Re: RNSH Community Facility Car Park and Loading Dock- Compliance Report

As requested we have undertaken a review of the drawings received on 22 October 2009 for vehicle circulation of the proposed car park and loading dock operation of the Community Facility to assess whether they are in accordance with AS2890.1. Our findings of the review are listed below.

Figure 1

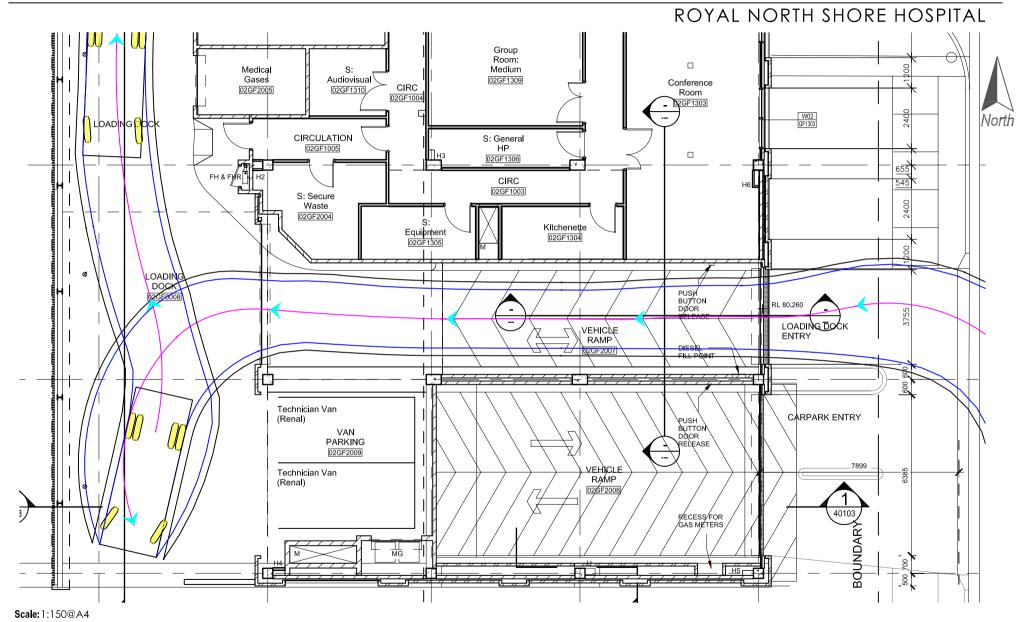
As requested we have tested a 6.4m Small Rigid Vehicle (SRV) servicing the loading dock. **Figures 1** and **2** indicate that a SRV could satisfactorily enter and exit the access in a forward direction.

Figure 4

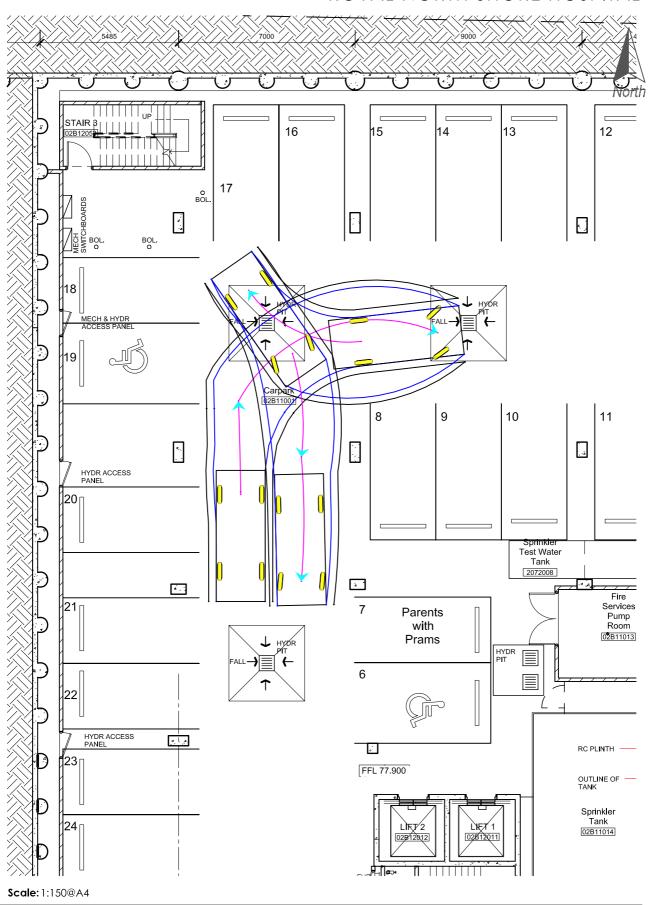
The basement car park does not have a formal turn around area, although as shown in **Figure 4** B99 vehicle could turn around at the end of the aisle. Therefore, unless these spaces are to be individually allocated, it is recommended that a monitoring system with a "CAR PARK FULL" sign display be installed in the driveway to indicate when the car park is full.
